Exhibit 4

RE: La Paloma Energy Center –Permit No. PSD-TX-1288-GHG

1. The Region Must Establish the GHG BACT Limit Based on the Most-Efficient, Lowest Polluting Turbine Design Technology.

Figure 1:⁴⁷

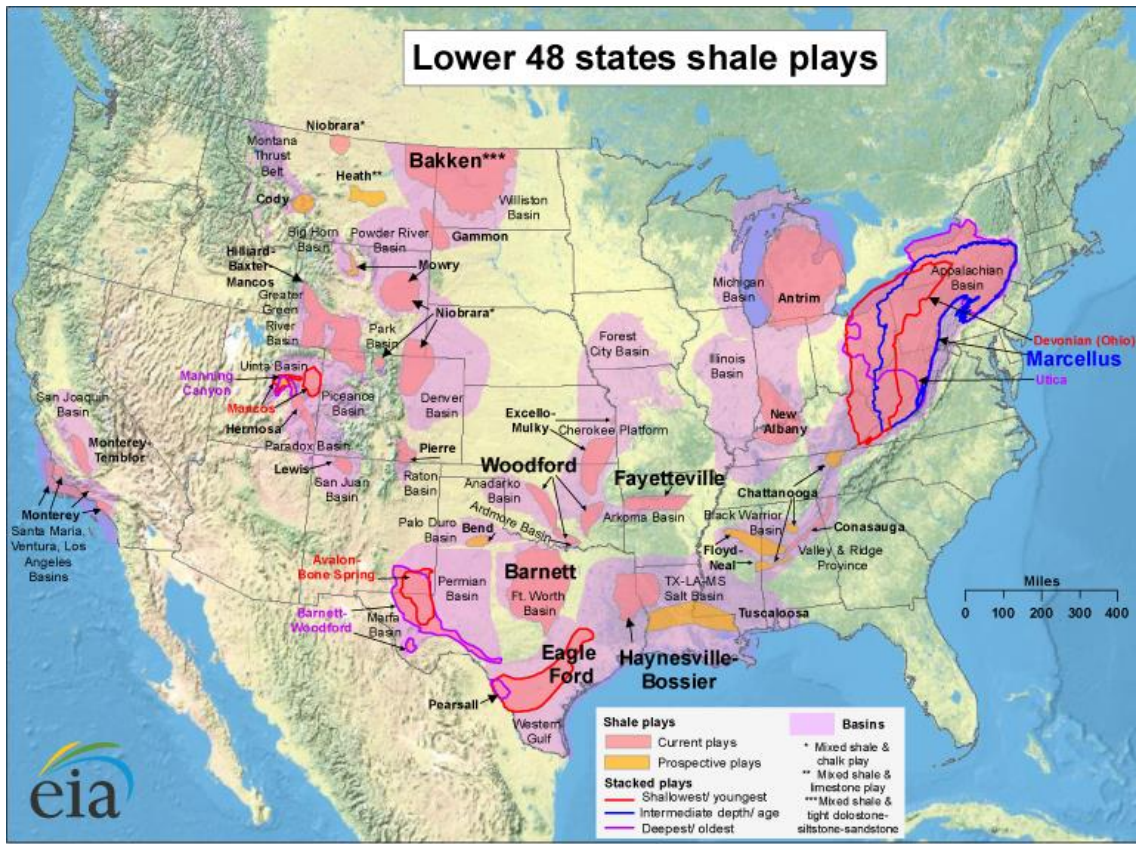
South Texas has recently experienced significant increases in crude oil and natural gas production from the Eagle Ford Shale basin.⁴⁶ LPEC is in the center of this large increase in natural gas drilling and production. Figure 1 below shows the extent of the Eagle Ford Shale basin, which includes the proposed LPEC site.

In addition to the large-scale development of natural gas production, there is also significant development of natural gas distribution pipelines for domestic use and for export occurring near the proposed LPEC site. The following Figure 2 shows the substantial existing natural gas pipelines and planned new developments for exports near the LPEC facility in Cameron County, Texas.

Figure 2:⁴⁸

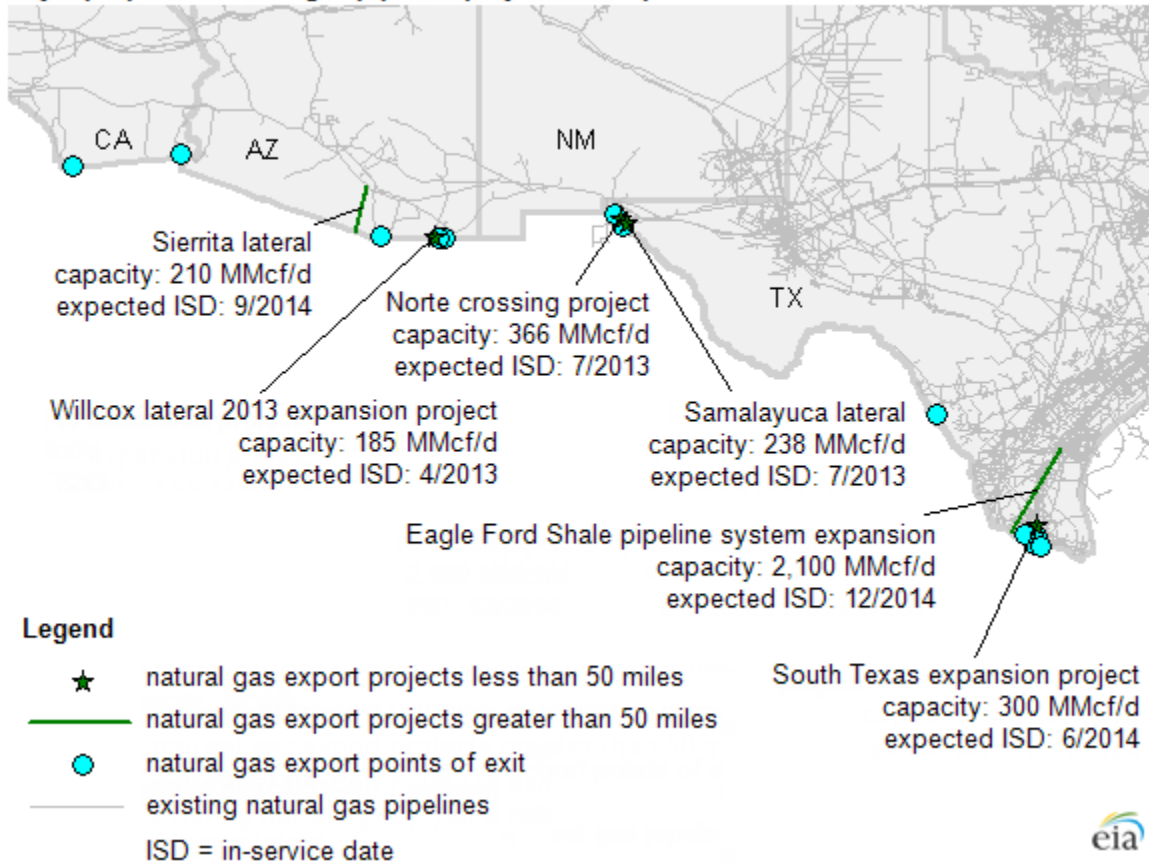
Major proposed natural gas pipeline projects for exports to Mexico

Air emissions from drilling operations are incredibly high. Wells, compressor stations, venting and blow down operations, processing plants, and other operations related to this substantial surge in development all contribute to GHG emissions and other pollutants. The proposed LPEC plant and other new natural gas facilities are products of this major increase in natural gas extraction and distribution. The Region must analyze in its PSD permitting process the increased air pollution that will result from growth in upstream natural gas production and distribution associated with increased natural gas use at LPEC. 42 USC 7475(a)(6). GHG impacts from these upstream operations include significant methane emissions. Indeed, petroleum and natural gas production, transmission and distribution are second only to power plants as a source of GHG emissions.⁴⁹ In addition, growth in natural gas production and distribution associated with LPEC will result in increased emissions of volatile organic compounds, fine particulate matter, and toxic air pollutants.

The Region should also consider these upstream emissions in its evaluation of alternatives to the proposed project and in its analysis of CCS as BACT. 42 USC 7475(a)(2), (4). Requiring CCS, either at the proposed location or at an alternative site closer to sequestration options, is especially critical in view of the high life cycle GHG emissions associated with burning natural gas for electricity
